REQUEST FOR INFORMATION

RFI# 0873

PROJECT: US Home Garage Corp Campus
BLDG 4: 730 Lake Drive
BLDG 5: 755 Lake Drive
Issaquah, WA 98027

SUBJECT: P10 Trellis CC line G-F

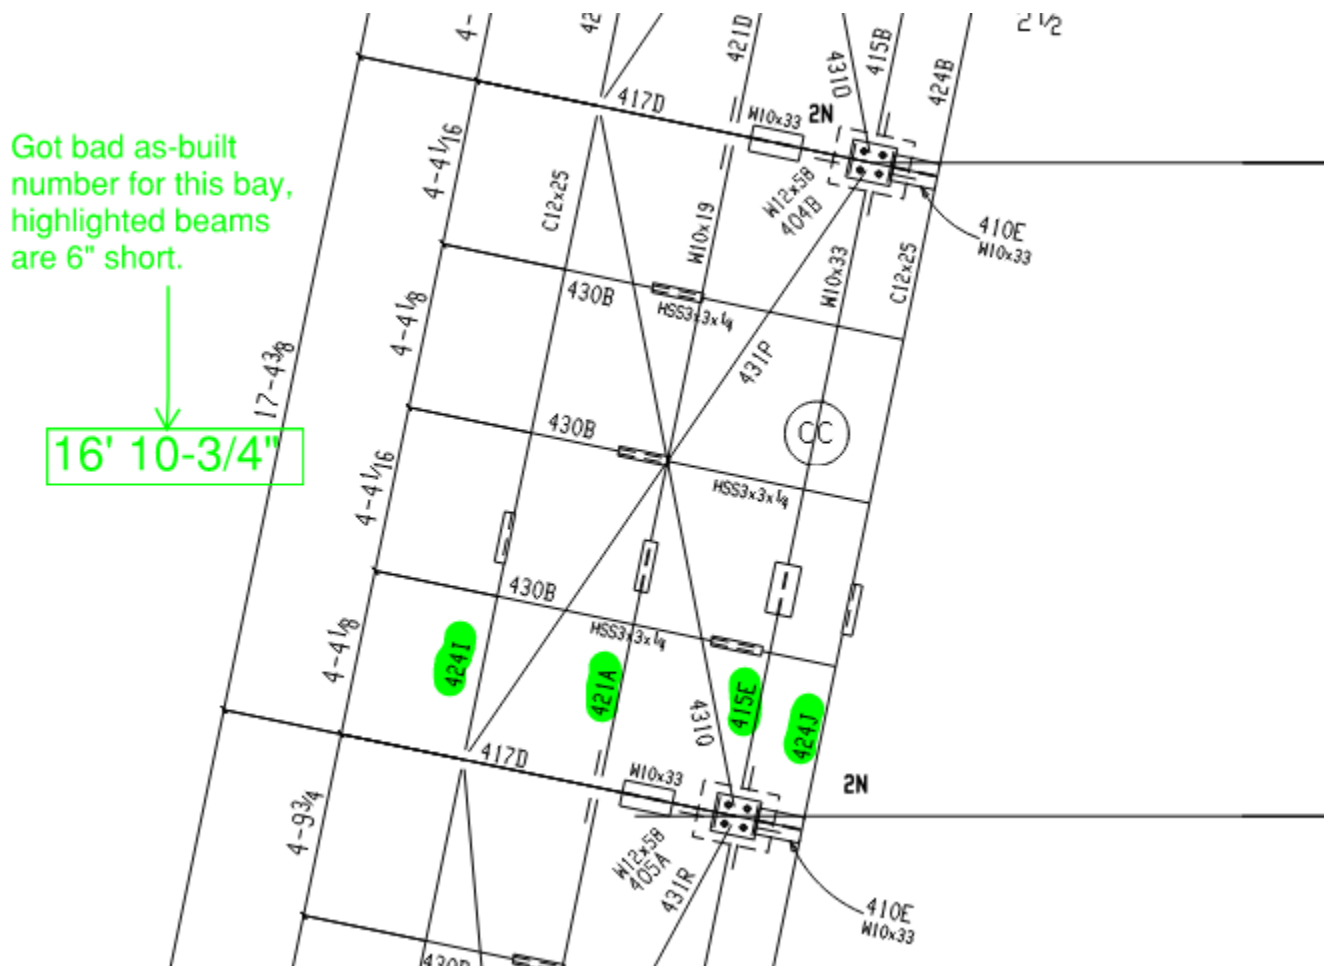
Req. #	Comments
Request:	IT appears we missed a measurement for a trellis grid on CC/ G-F. We will replace the "C" on the perimeter to keep the fascia continuous, however, is there a possibility to have extension clips for the WF beam. Please advise.
Solution:	Extension Clips each end of WF

Can we get RFI approval in the works to Cesar? Ironworkers found a bay that was dimensioned wrong during as-builts. Must have measured between inner bolt pair. Occasionally had concrete blob on bolts, so remove duct tape from other pair for dimensioning. Apparently did not catch that one for center to center.

Want to see if we can weld these connections to the tabs provided, and piece in channel shortage as well.

ENW
YES. ADD CLIP EXTENSIONS FOR WF BEAM. AT BOLTED CONNECTIONS FIT ALL AVAILABLE BOLTS (MID BEAM AND TOP AND BOT PLATES). ARCH TO VFY IF WE NEED TO ADD BOLTS FOR VISUAL CONSISTENCY. KEEP WELDS AT TOP AND BOT PLATES AS DETAILED.
CR
11-02-2021
